UNITED STATES PATENT AND TRADEMARK OFFICE

10/511,227

Office Action Summary	Application No. 10/511,227	Applicant(s) PINCEMIN, ERWAN	
	Examiner LI LIU	Art Unit 2613

DETAILED ACTION

Figure O1

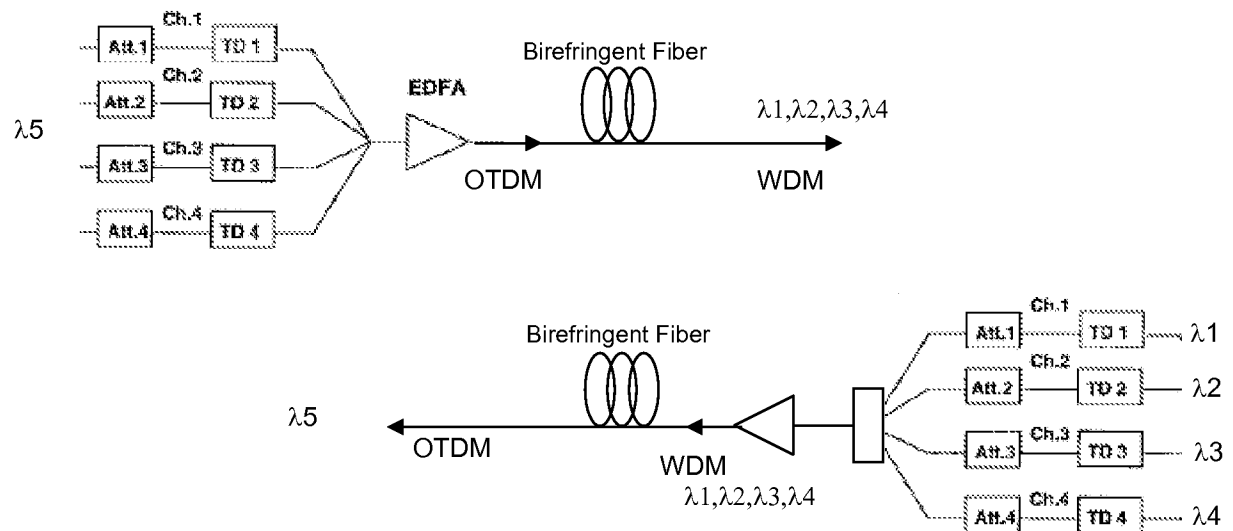
Hatami-Hanza et al teaches a birefringent propagating medium (e.g., the Fiber Span in Figure 1), and the OTDM signals with a signal wavelength are injected in the birefringent propagating medium to achieve a soliton trapping phenomenon (page 834, Figure 2, the pulse shape is not deformed but the frequency shift occurs, and the amount of shift depends on the pulse peak power), and then a WDM signals with four

Based on the non-linear optical theory, and also indicated by Hatami-Hanza et al, the amount of frequency shift depends on the pulse peak power. As shown in the top panel of Figure O1, the pulse power level can be controlled by the attenuator (Att. in Figure O1) and the timing position of the pulse is controlled by the time delay (TD in Figure O1), and then through the birefringent fiber, the single wavelength OTDM signals are converted into WDM signals having four different wavelength. It is obvious to one skilled in the art to use the same principle and the birefringent propagating medium of Hatami-Hanza et al to convert the WDM signal to OTDM signal. As shown in the bottom panel of Figure O1, the attenuator (Att.) and time delay (TD) can be used to control the power level and timing position of the pulses of the WDM signals which are simultaneous and carried at the different wavelengths, then the birefringent fiber can be used to convert the four-wavelength WDM signal into single wavelength OTDM signals.
